## **MIDVALE PLANNING AND ZONING COMMISSION MEETING AGENDA NOVEMBER 9, 2016**

**Planning and Zoning Commission Staff Report**

**APPLICATION:** CHG Office Building & Campus –  
Revision to Exterior Materials

| <b>APPLICATION:</b>              | <b>GANESH RESTAURANT</b>                  |

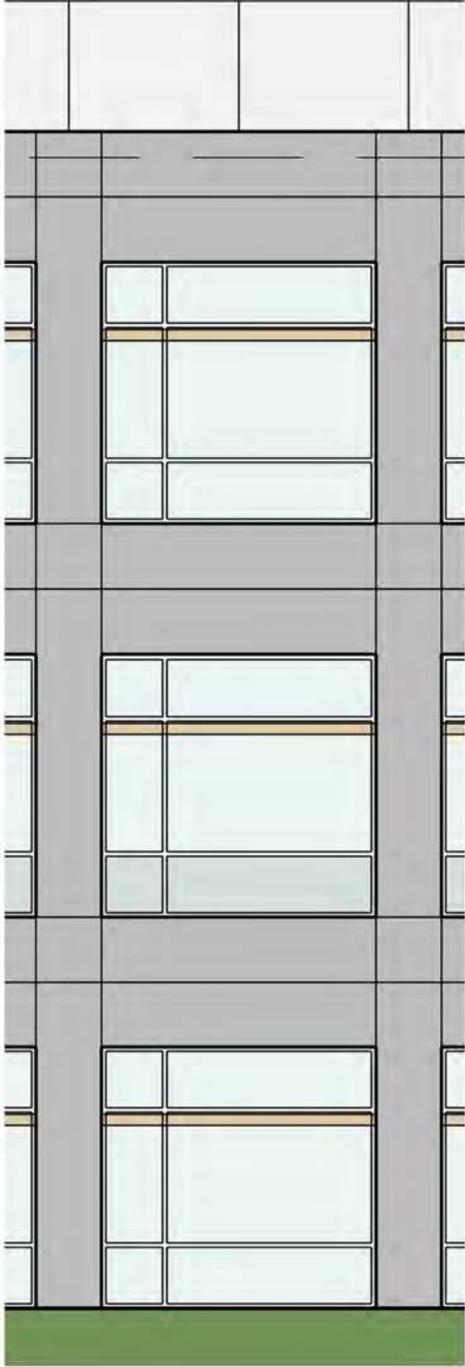
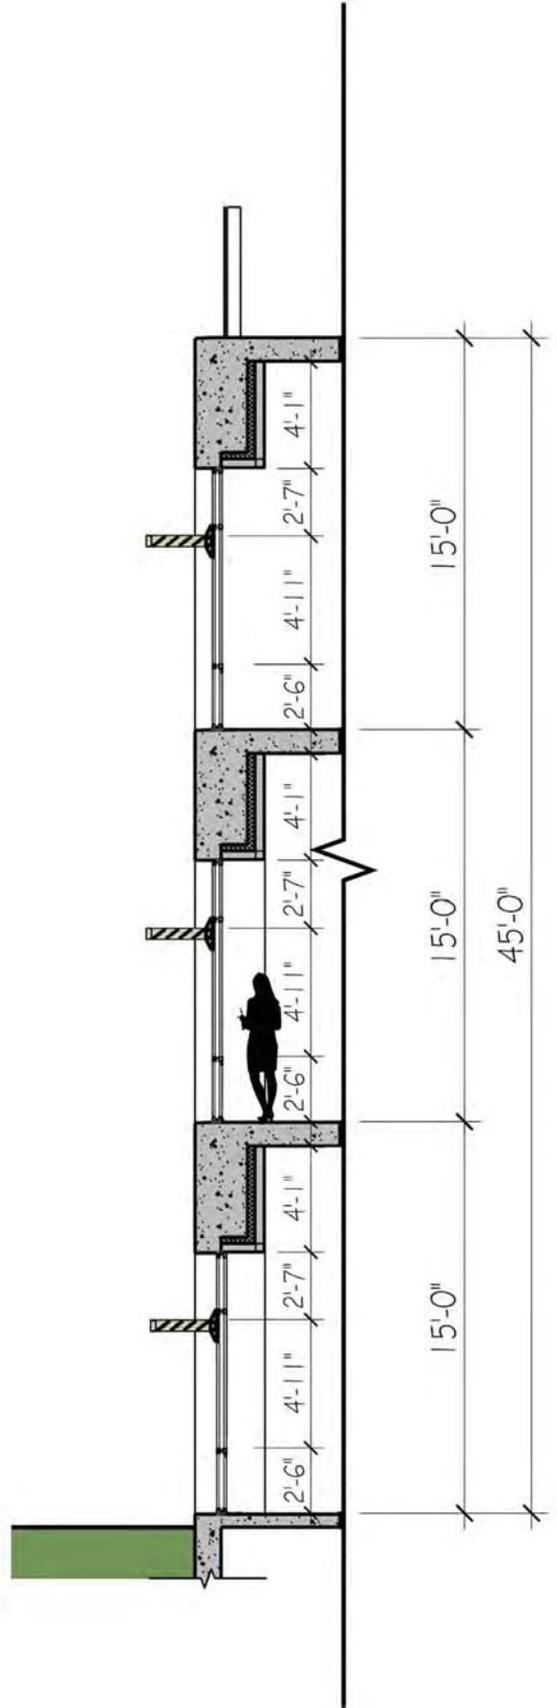
At this time, Overstock is requesting approval to eliminate the sunscreens (metal awnings) included on the approved building elevations. The applicant has submitted a written explanation and photos of the building to show the reasoning for this request.

Overstock.com is requesting a change to what was previously approved by the Midvale City Planning Commission. Specifically, Overstock is requesting approval to eliminate the sunscreens that were originally shown on the concept drawings, reviewed with the Planning Commission, and included in the construction documents. The sunscreens, located at each punched opening around the perimeter of the building, were not included as part of the construction. Due to an unintentional oversight, this change was not shared with the Midvale City staff as part of the numerous value engineering modifications that were made to the building during the course of construction.

It is Overstock's position that the sunscreens are not necessary, based on the fact that Overstock spent an additional one million dollars upgrading the glazing on the exterior of the building to View Glass. View Glass is a state-of-the-art dynamic glass which has the ability to automatically darken and shade the interior of the building depending on the time of the year, the time of day, and the exterior weather conditions. This capability provides the occupants with a more comfortable and productive work environment.

Originally the sunscreens were designed to limit, not eliminate, direct sunlight into the building and as such also provided a horizontal accent on the exterior of the building. The fact that the sunscreens are no longer necessary for sun control, Overstock and the design team do not feel that simply maintaining a horizontal steel band is consistent with the original intent of the screens. From the interior of the building the horizontal band also becomes a visual distraction to the views out of the building. While the screens did provide some additional detailing on the exterior of the building, the fact that they now provide no functional value makes them simply an applique rather than a functional design element. The design team feels that the strength of the building and its design aesthetic is in no way compromised with the elimination of the sun screens. In fact, with the integration of View Glass and the elimination of the sunscreens, the building is a more honest representation of its state-of-the-art capabilities.

Staff would recommend that the Planning Commission discusses and considers the request to eliminate the sunscreens as a required architectural element on the Overstock Peace Coliseum building. If the Planning Commission determines that the building complies with the architectural standards for a commercial building in the Junction at Midvale Overlay without the sunscreens, Staff would recommend approving this request.

*“Based on the existing Overstock Peace Coliseum building complying with the form variations, and window and architectural treatment standards of the Junction at Midvale Overlay, I move that we approve the applicant’s request to eliminate the sunscreens (metal awnings) on the building exterior.”*

EXTERIOR ELEVATIONS AREA 2  
**A205**

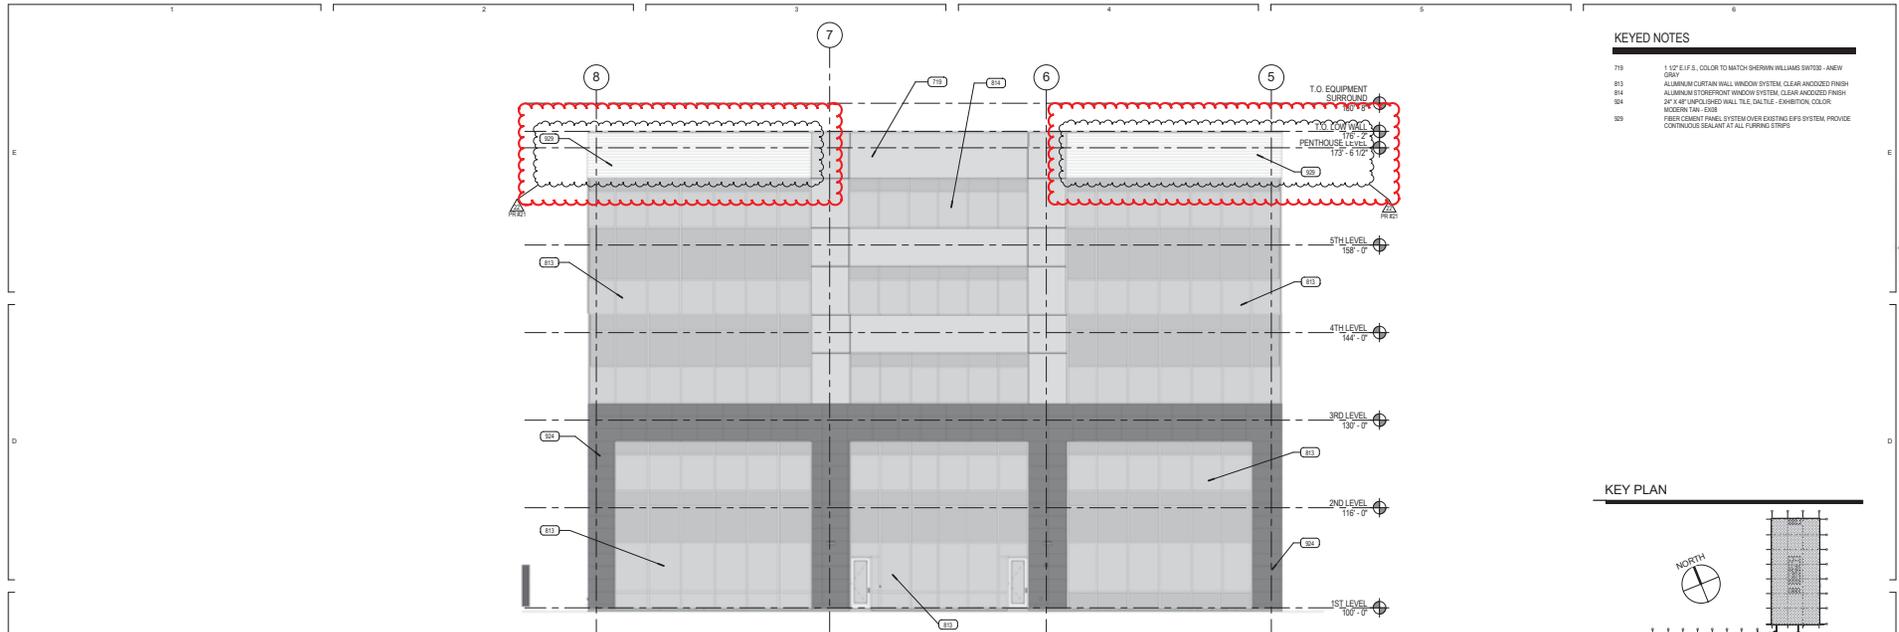
The applicant has made a request to install some accent panels along the exterior of the identified building under construction. The applicant has stated the purpose is to, “dress these buildings up a bit and give them a little more character and definition.” The applicant has provided a proposed plan and renderings of the Nichiha composite panels, an exterior alternative material that can provide the look of metal, stone, brick, concrete, wood, etc.

Based on Staff's review, it appears all proposed elevations will be replacing the existing and approved E.I.F.S. material with the proposed accent panels excluding the North West Elevation Area 2 (Sheet A205) which will be replacing the existing and approved wall tiles.

Staff recommends the Planning Commission approve the revised exterior material proposal for the CHG Office Building & Campus.

*"We find that the revised building elevations for the CHG Office Building create detail and relief with the exterior materials proposed, adds to the architectural excellence of the structures and overall project, and complies with the intent of the ordinance, and we therefore approve the revised building elevations, as proposed."*

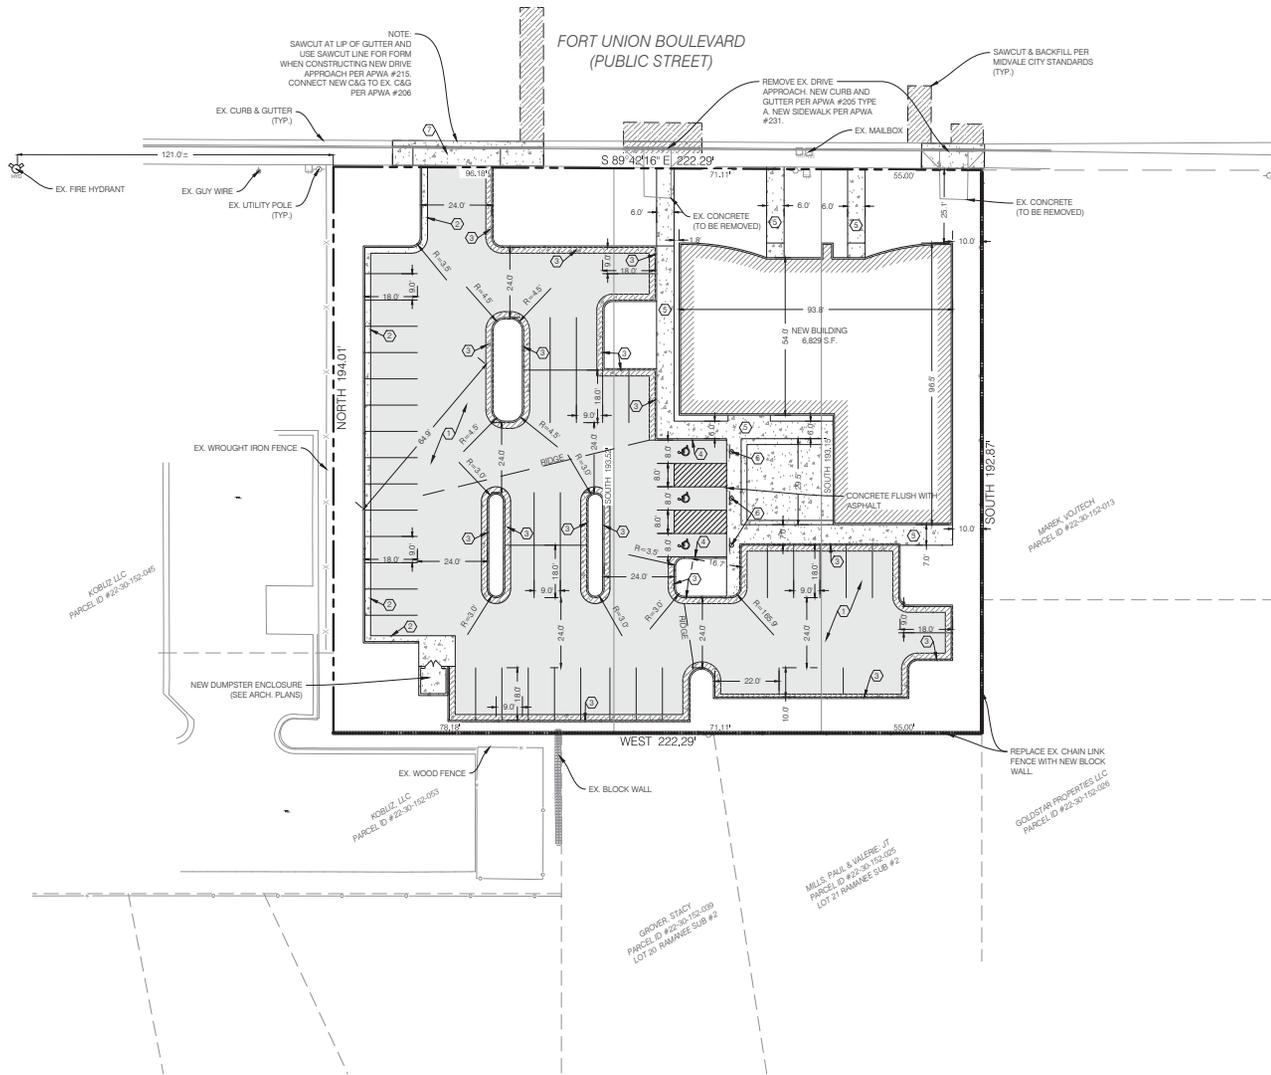
The applicant is requesting a twenty-foot (20') reduction along the east property line, making the landscaped buffer ten-feet (10') wide with a six-foot high pre-cast concrete fence separating the two uses. The proposed landscape plan includes several varieties of deciduous trees. These proposed landscaping features are anticipated to reach a mature height of 25 feet to 40 feet. The applicant is also requesting between an eighteen-foot (18') to twenty-five foot (25') reduction along the south property line, making this landscaped buffer area between five-feet (5') to twelve-feet (12') in width with a six-foot high pre-cast concrete fence and several varieties of deciduous trees and evergreen trees and shrubs. These proposed landscaping features are anticipated to reach a mature height of 6 feet to 30 feet. A copy of the proposed site and landscaping plans are attached.

We are asking for a reduction in the thirty-foot wide 'landscaped buffer' area in the following areas:

1. East side of the project: A ten foot wide planting area - we have increased the number of trees and a six foot high precast fence will be placed on the property line. The trees, when mature will vary from 10 to 30 feet tall and up to 15 feet in diameter. There will not be any operable glazing installed on the east side as well.
2. South side of the property shall be receiving the same six-foot high precast fence to matching the existing at the neighbor to the west. There will be a heavily landscaped planter approximately twelve feet wide with trees that will vary from 12 to 30 feet tall and up to 15 feet in diameter, and parking. The closest the building will be to the south property line will be seventy-two feet.

Based on the reduced landscape buffer with the proposed six-foot concrete fence and landscaping providing adequate screening, buffering and separation to protect the adjacent residential uses from the impacts of a commercial development, Staff recommends that the Planning Commission allows a reduction to the 30-foot residential landscape buffer requirement along the south and east property lines of the proposed restaurant use known as Ganesh Cuisine Restaurant at 130 East Fort Union Boulevard with the following conditions:

1. The landscape buffer shall be constructed as shown on the revised site plan and shall include the proposed trees, shrubs, and landscaping, as shown.
2. A six-foot high pre-cast concrete fence shall be constructed along the south and east property boundary of the proposed area, as shown on the revised site plan.
3. The proposed restaurant use site plan shall comply with all other applicable requirements of the Regional Commercial Zone and the 7200 South Overlay.
